Using FusionAir Smart Sensors with older controllers

Summary

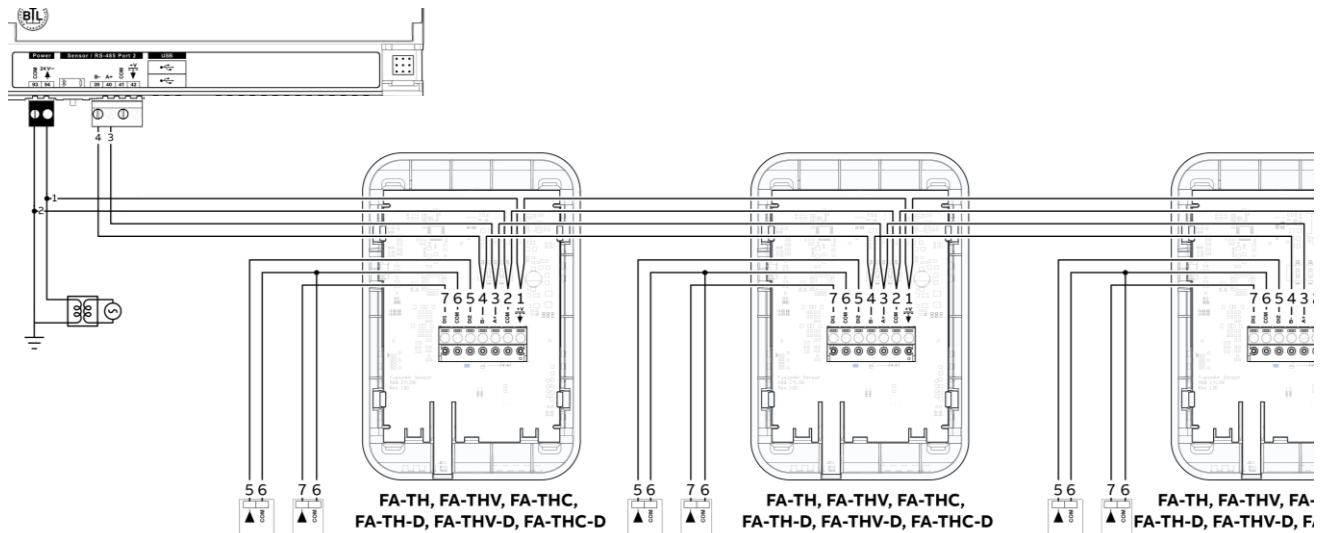
For the following controllers however, the power line for the sensors should be taken from an external 24 V source:

- CBX-8R8 and CBX-8R8-H
- CBXi-8R8 and CBXi-8R8-H serial number **CBXixxxxxF** or earlier
- FBXi-X256 serial number **FBXixxxxxF** or earlier
- FBVi-2U4-4T serial number **FBVixxxxxD** or earlier.

For these controllers, the power line for the sensors should be taken from an external source as illustrated below:
